QuadraTouch™ V2.6 Software Change Log

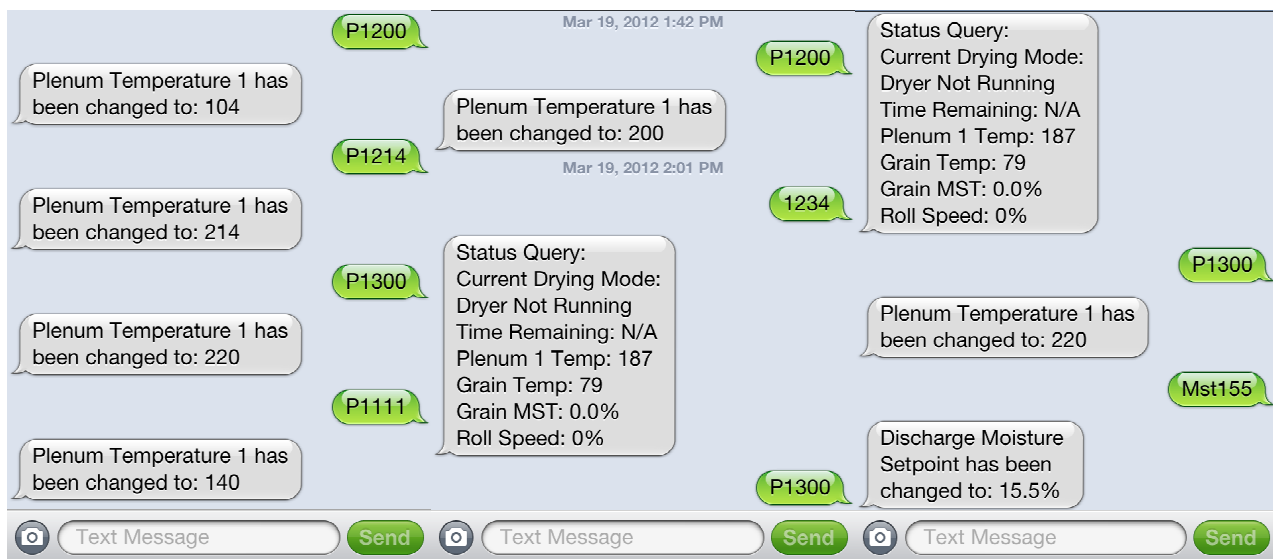
Changed the look of the "Reset" button.
